Stag Brewery, Mortlake

Masterplan and Detailed Design and Access Statement - Addendum

For Reselton Properties

July 2022

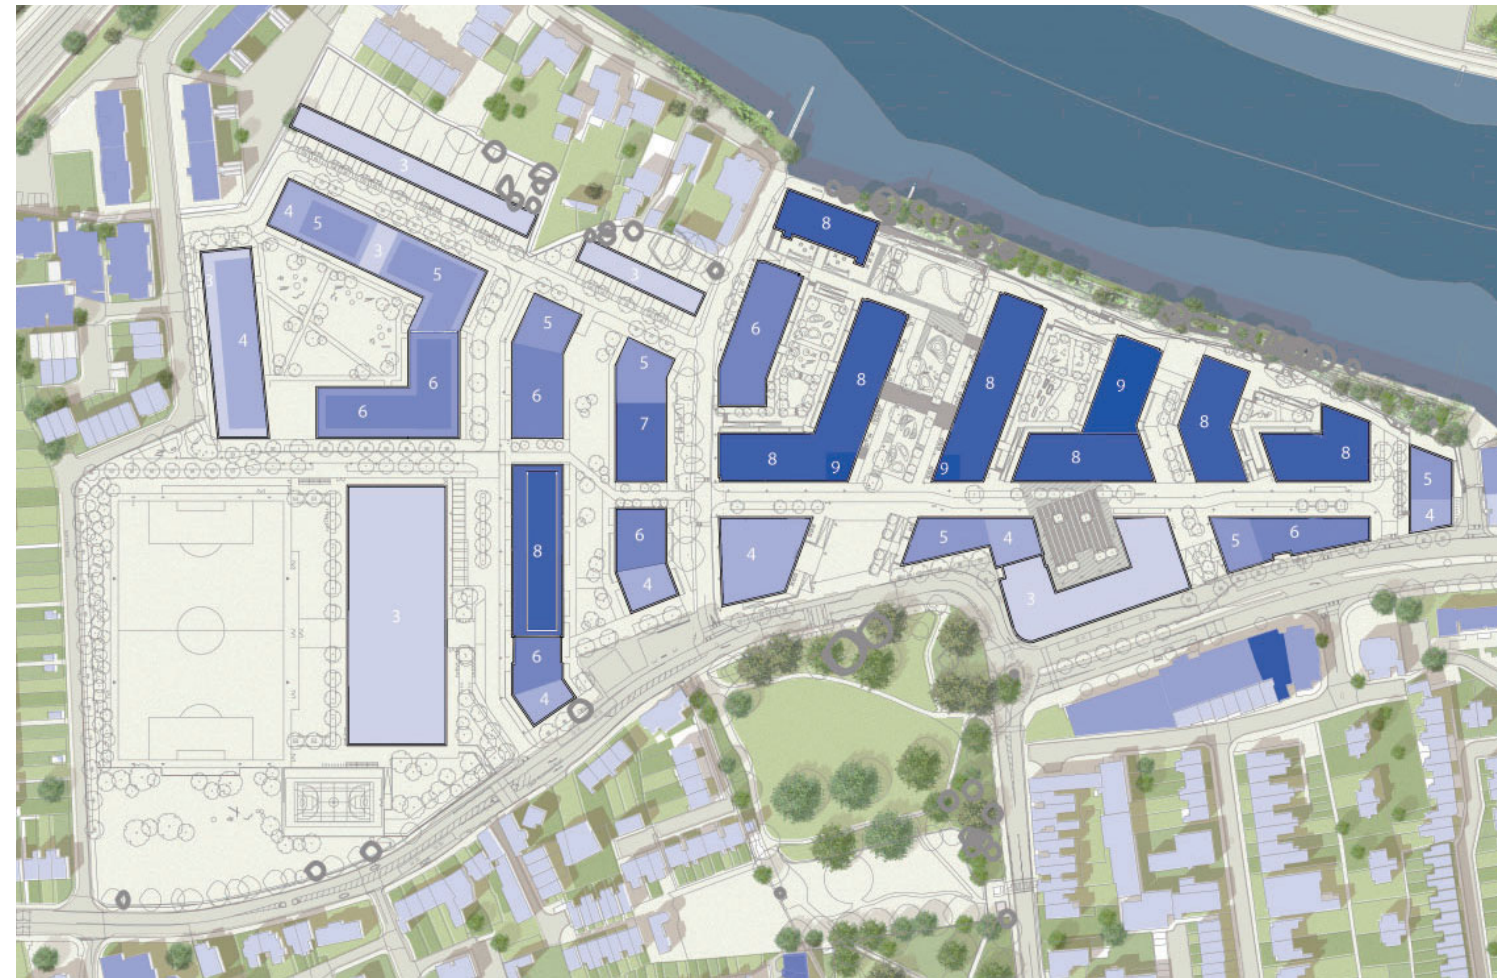
The layout of the top floor of Building 1 has been amended, with the extent of the office building reduced, to reduce the massing of the building.

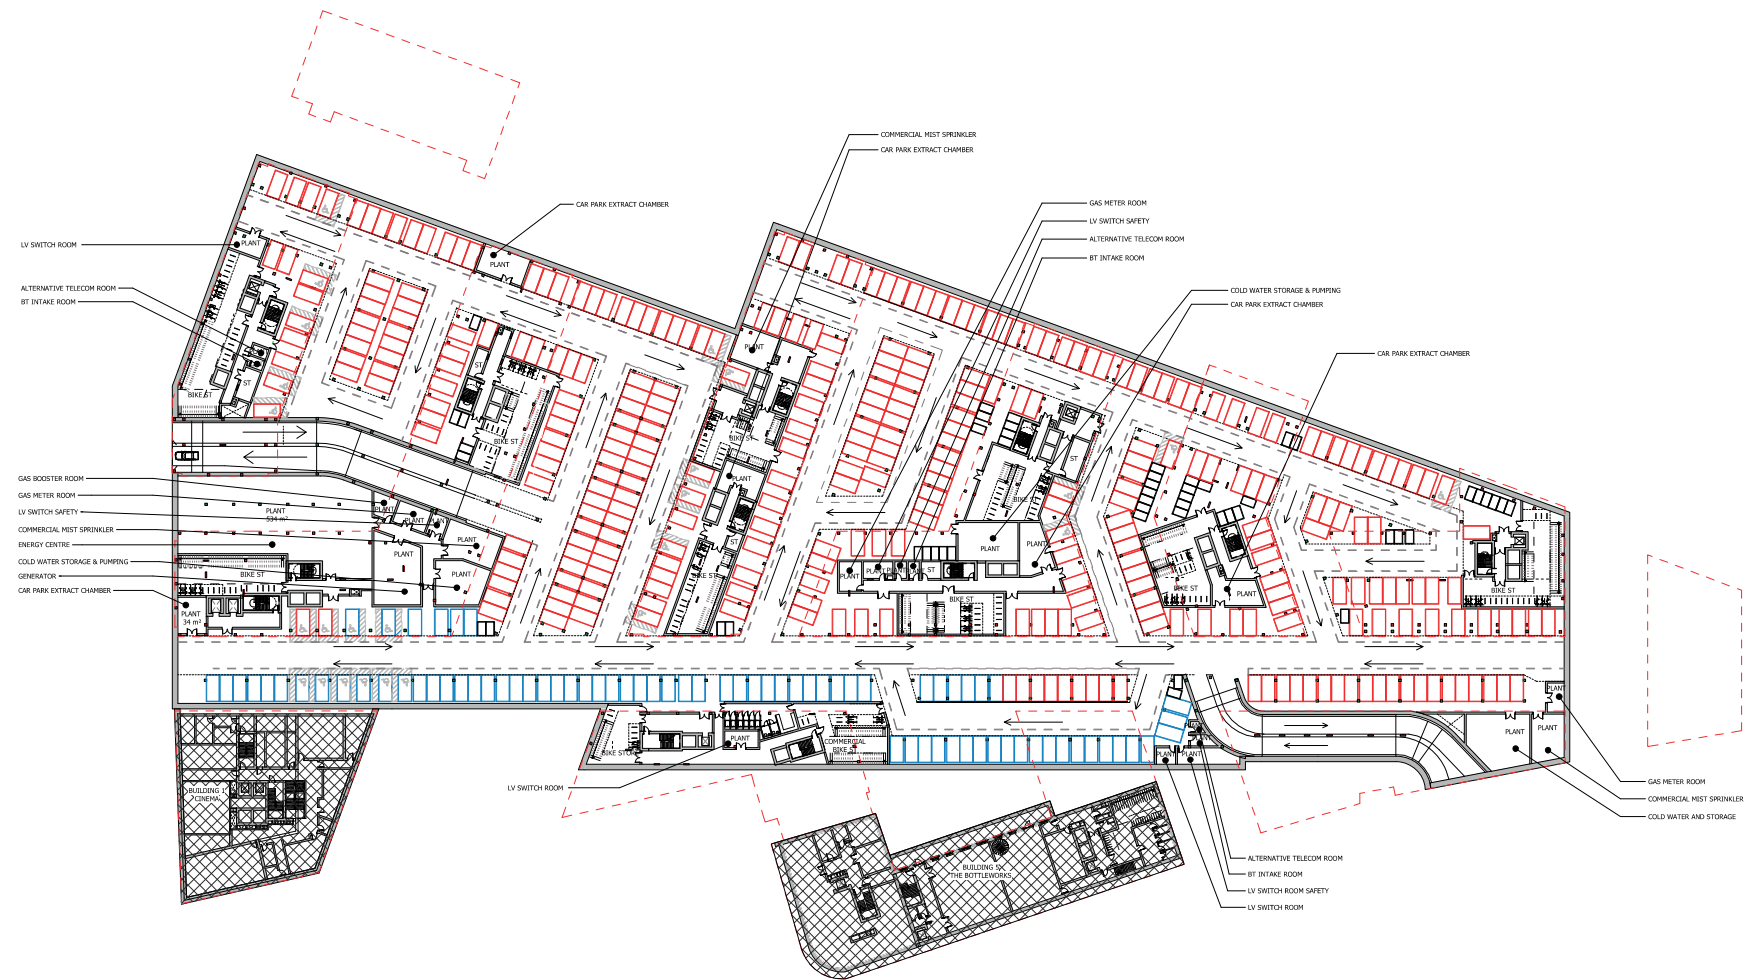
The principles of fire strategy have not fundamentally been revised but elements of additional fire safety have been incorporated to enhance the fire safety of the scheme. Most of the buildings are single stair buildings with smoke extract ventilation where required to corridors and lobbies and this remains the case. However, the clear separation of the basement from the ground floor, through the disconnection of stairs and lifts, has ensured a higher degree of protection from fire and smoke transferring from the basement to the rest of the building.

Smaller changes have also been made at ground floor, including the removal of any dual entry fire-fighting lifts and the separation of refuse stores from the inside of the building, so that they are only accessed from outside. The disabled refuges have also been indicated in stairs and in relevant buildings evacuation lifts will be provided.

Revised Development Area 1 Basement plan

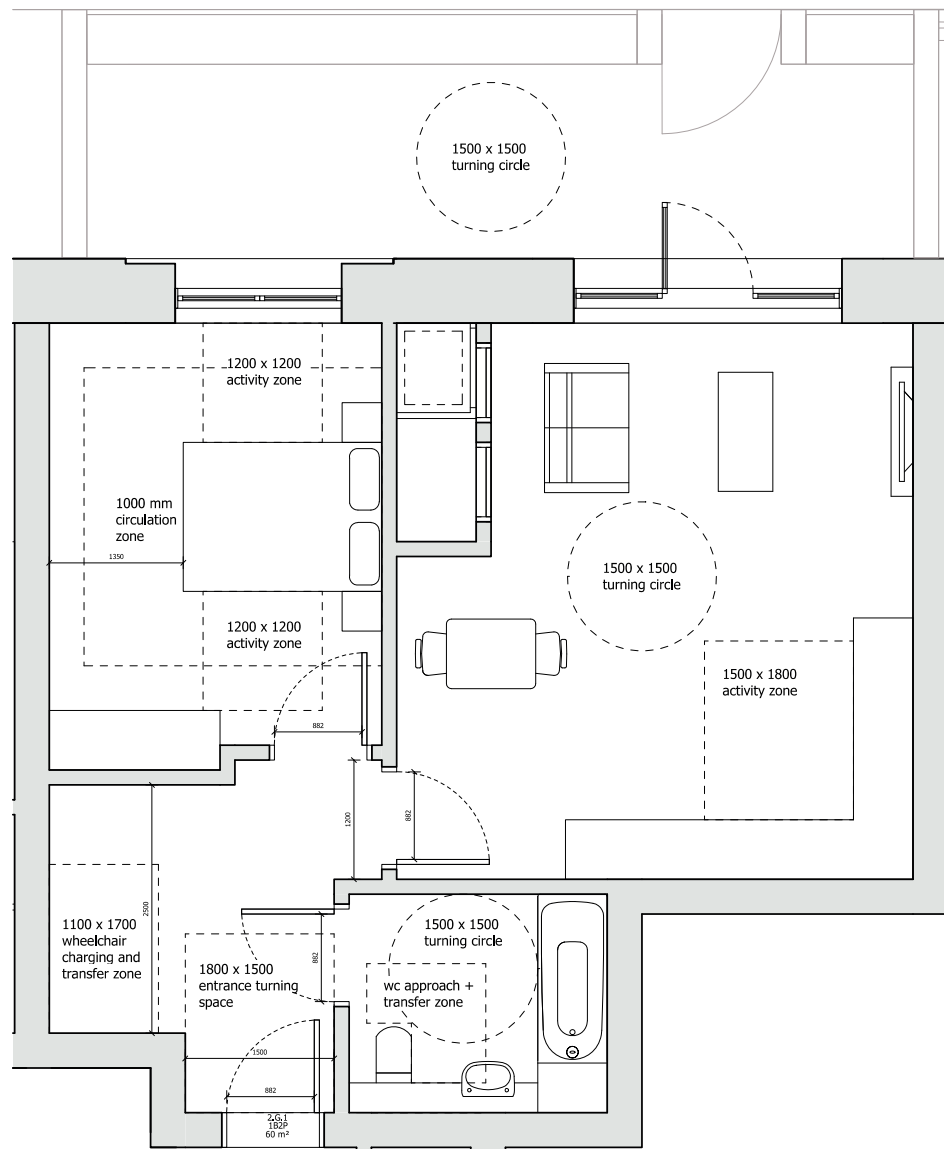
The layout of the basement has been amended to include the additional lifts from ground to basement, the relocation of refuse stores to ground floor and the reduction in car parking spaces.

A more major change to the basement has been the removal of refuse stores to the ground floor. This has allowed more space to include better cycle store provision and better arrangement of lobbies around staircases.
